ADDENDUM NO #2 (Rev 10/2025)

ISSUE DATE: **October 29, 2025**

RE: **BABCOCK HALL CENTER FOR DAIRY RESEARCH PLANT UPGRADES**
University of Wisconsin – Madison
Madison, Wisconsin
MSN Project No. 0106-2330 / UWSA Project No. A-23-001

FROM: **Foth Productions Solutions**
2121 Innovation Court, Suite 100
De Pere, WI 54115

ECN NO.	LTR	REVISION	BY	DATE	DRWN BY:	CHECKED BY:	DATE	PROJECT NO.	D. SIZE
23/005	A	ADDENDUM 1	FOH	10/28/2025	10/28/25	N.T.S.	10/28/25	23U005-E-0014	D

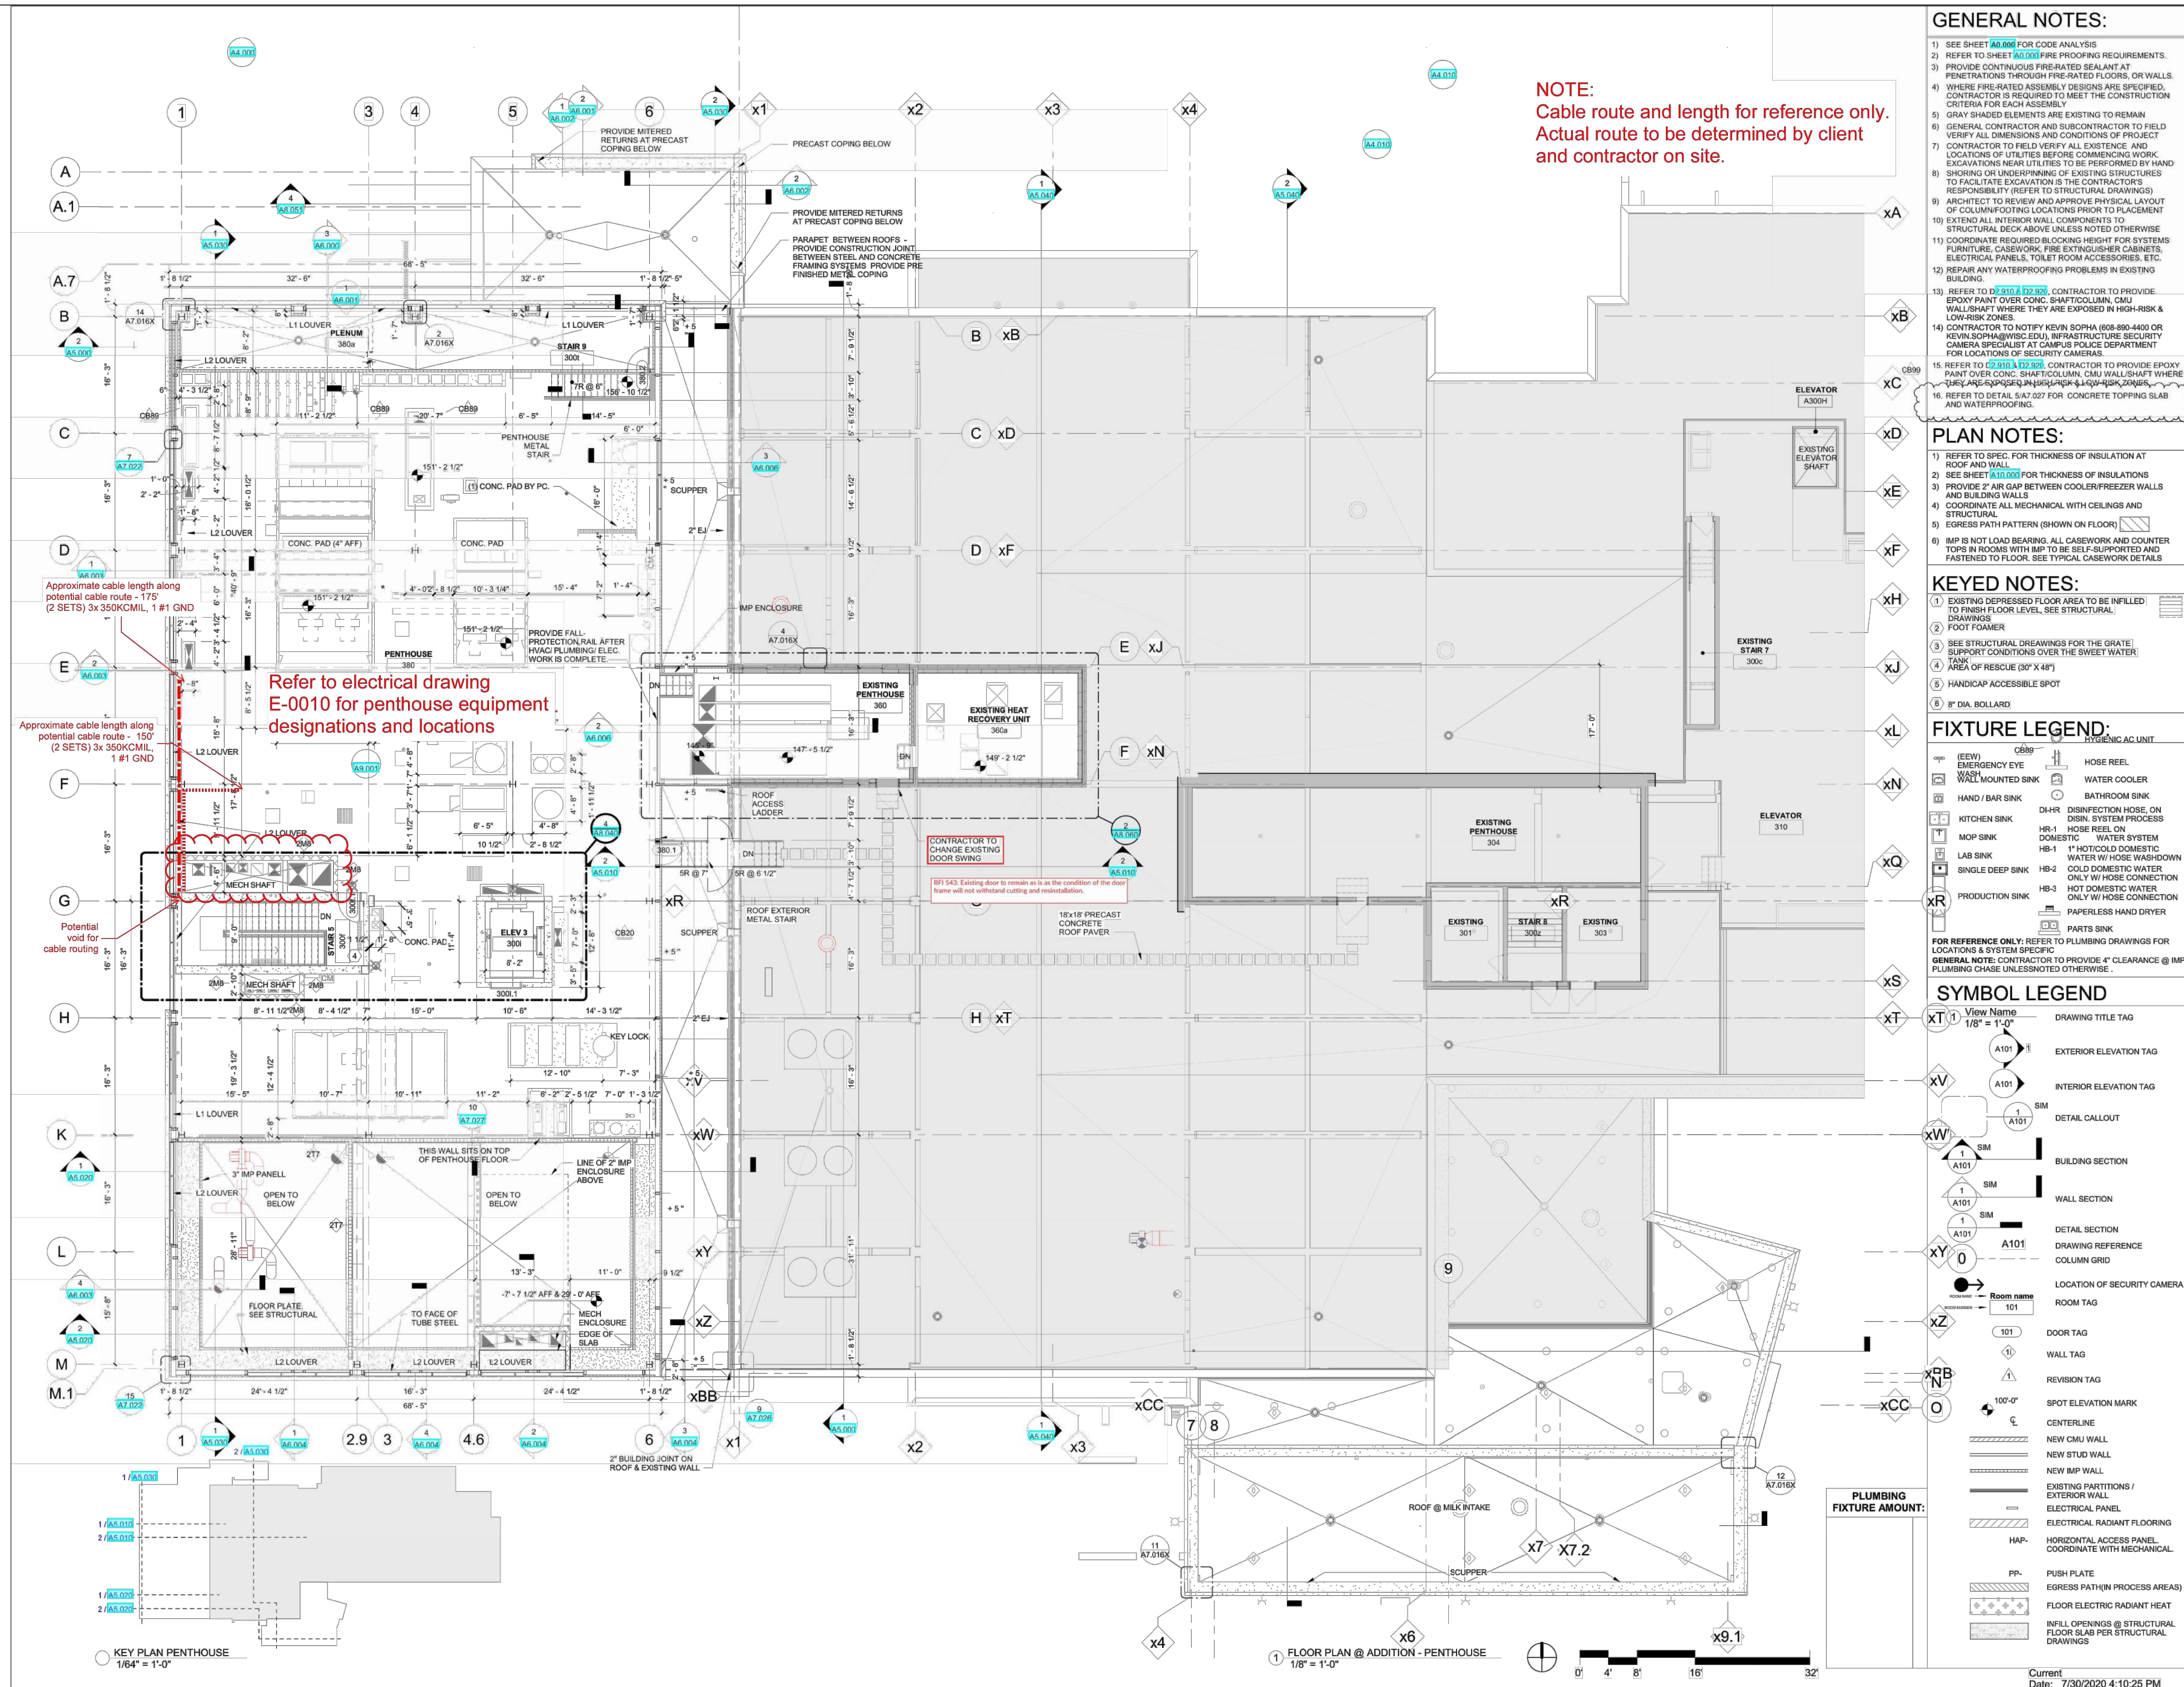
CONTRACTOR QUESTION: Without being able to see/ get into the electrical room for MSB/HA it was hard to get a measurable length for the feeder to PDP-480V. The plans do not show the basement or a route between the MSB/HA and panel PDP-480V. Is there a length/allowance that can be given for this feeder?

RESPONSE: See attached reference drawings 23U005-E-0012 through 23U005-E-0016 for proposed wire and cable routing and approximate lengths.

NOTE:
Cable route and length for reference only.
Actual route to be determined by client
and contractor on site.

Cables FROM transformer
TO PDP-240 will go from
penthouse to second floor
